**AGENDA PACKET**

**DECEMBER 21, 2021 MEETING**

**AGENDA**

**Tuesday, December 21, 2021**

SP/1

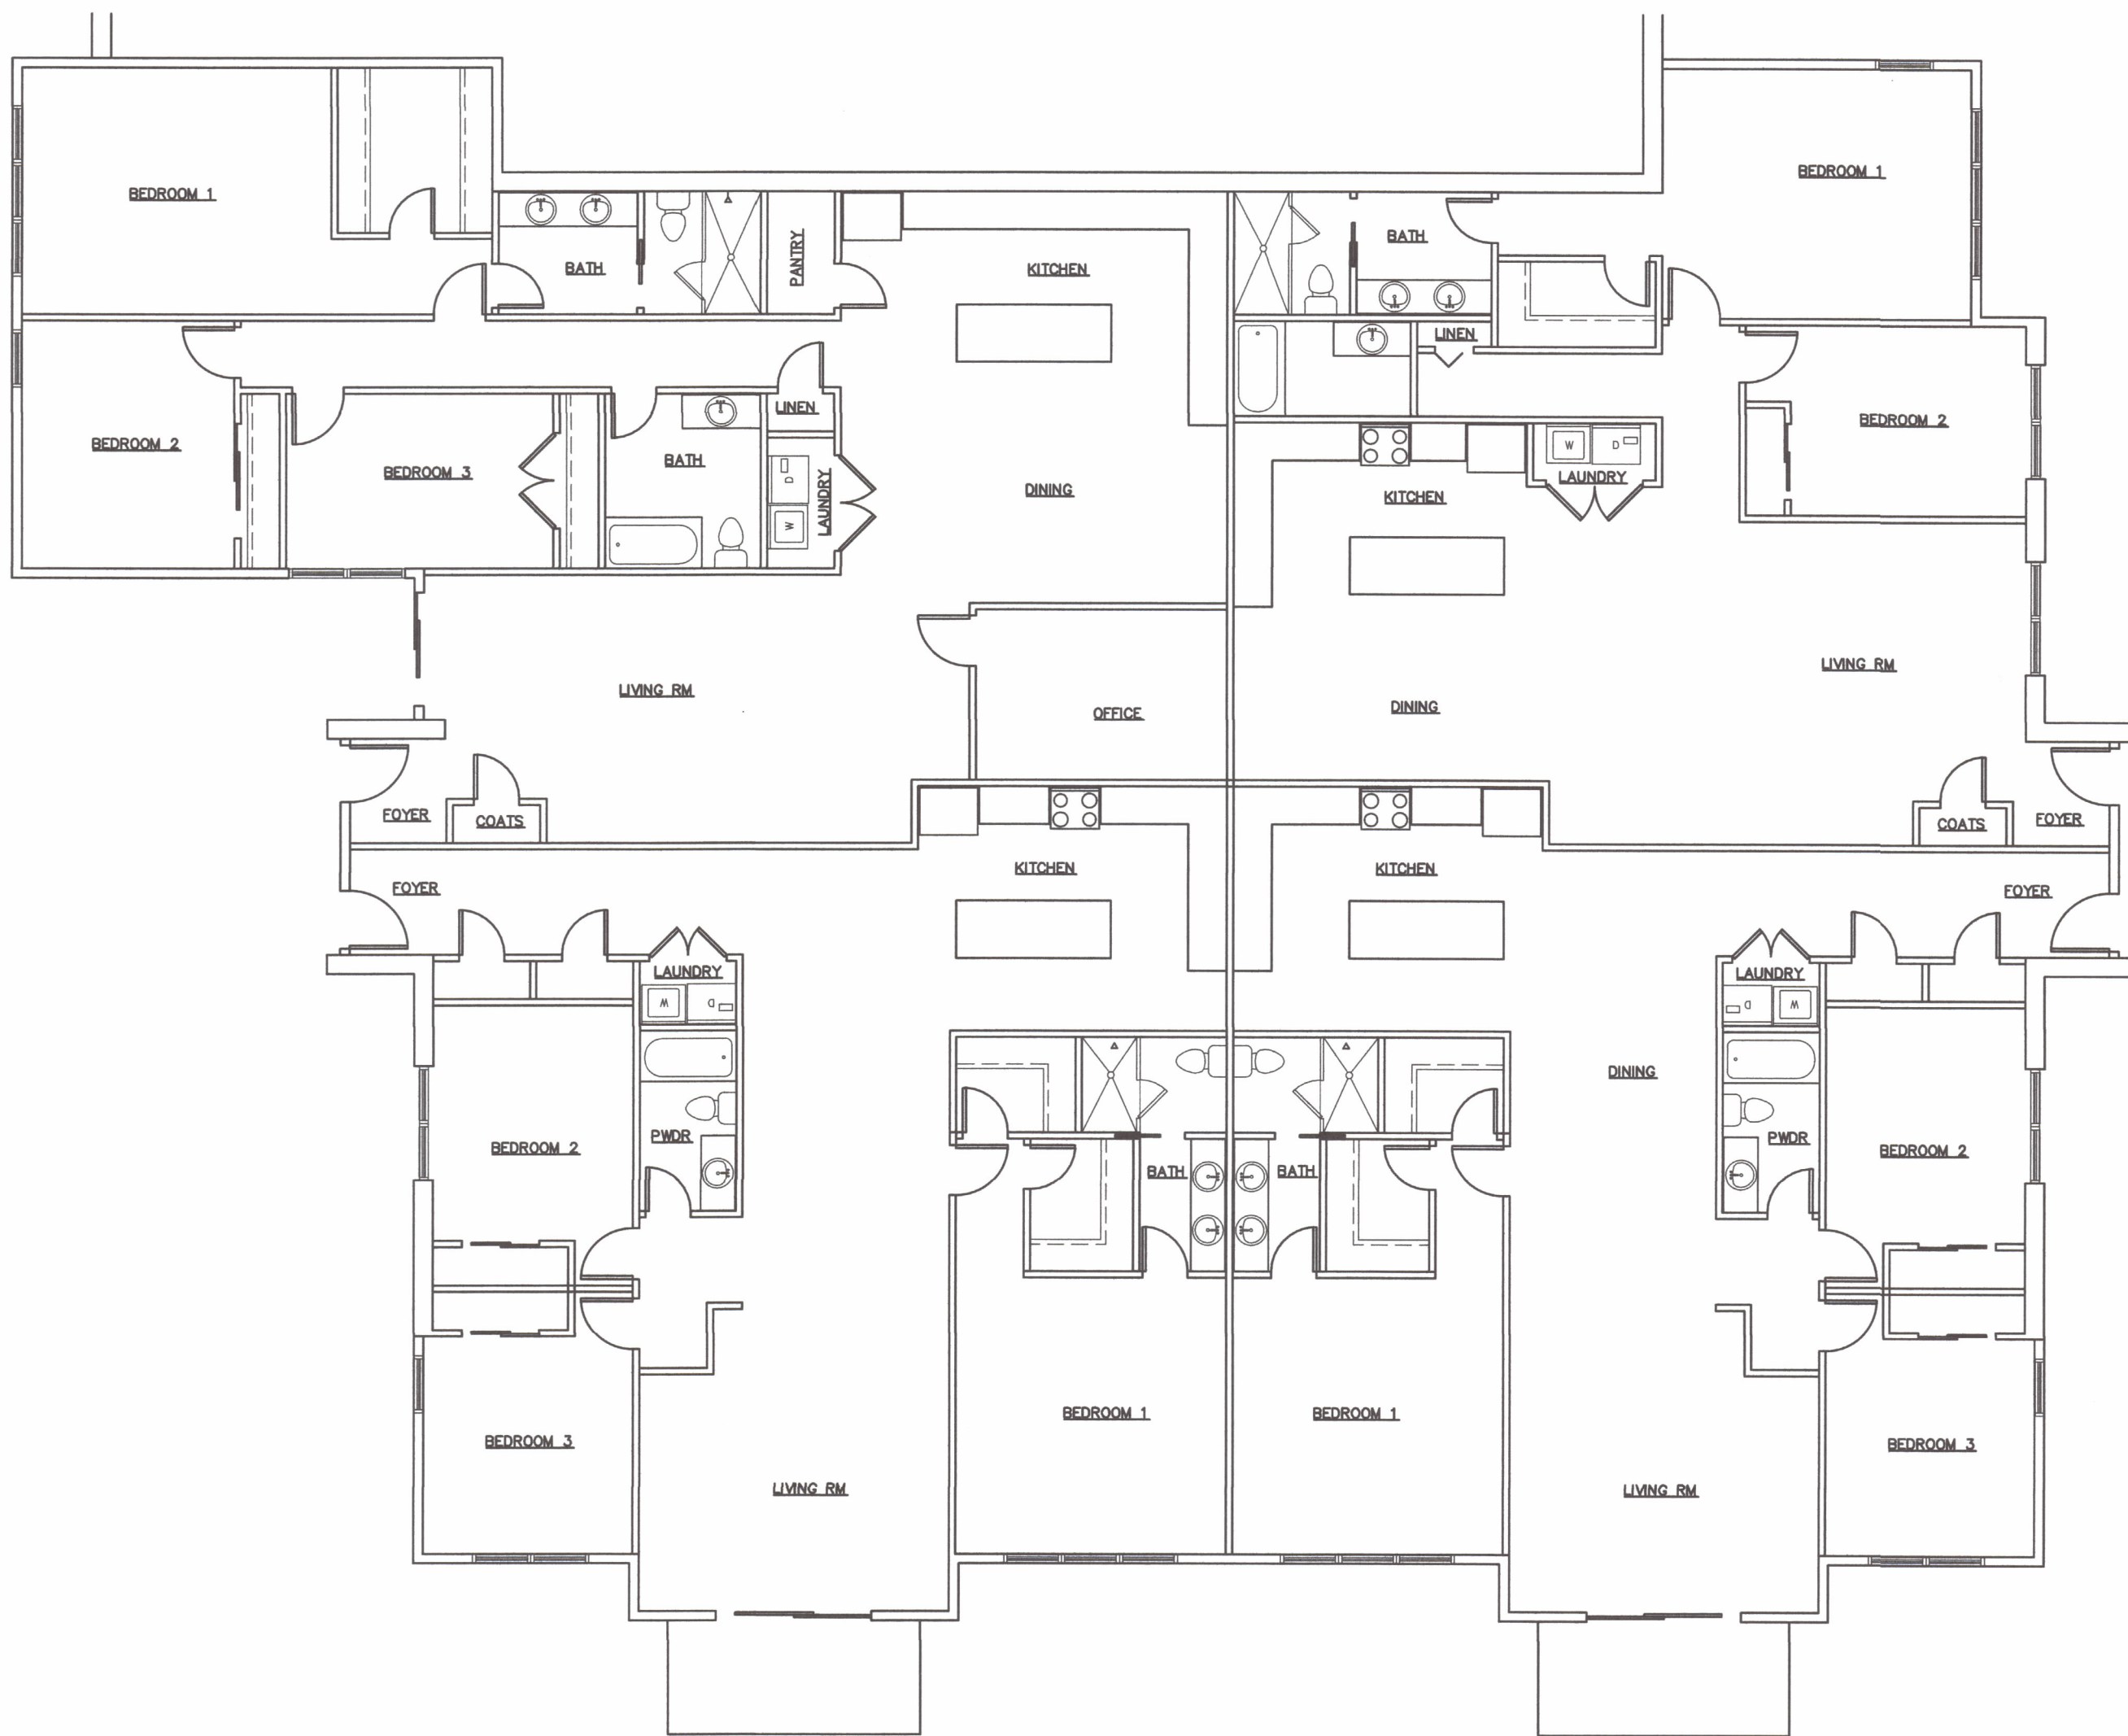
1. The board requested that we delay the submission to the Building Inspector until floor plans are ready.
2. No response required.
3. Oakridge Condominium is being contacted to see if they are amenable to the four proposed apartments sharing their recreation facility. If they are not amenable, the required fee will be paid.

4. The floor plan is currently being designed, but should be available for the public hearing.
- 5A. This matter was discussed at the Lewisboro Town Board meeting on Nov 22, 2021. They requested a letter from WCHD. It is on the Dec 9 agenda.

- 5B. The applicant is proposing that any residential expansion on site will include a minimum of three electric vehicle charging stations, but that they not be added at this time. A note indicating same is now located on drawing SP1.

- 5C. The applicant has requested a letter from Westchester County Health Dept indicating whether their approval is required. We have been verbally told that it is not required and that they have no objection. We will continue to pursue their response in writing.

- 5E. Notes have been added to Drawing SP1 indicating any future residential expansion of non-residential space will include the reconfiguration of the parking lot to eliminate unnecessary and non-required parking and improvements to on-site landscaping and lighting. A note was also added indicating that any future residential expansion will include the currently proposed residential units when calculating required affordable housing units, if any.
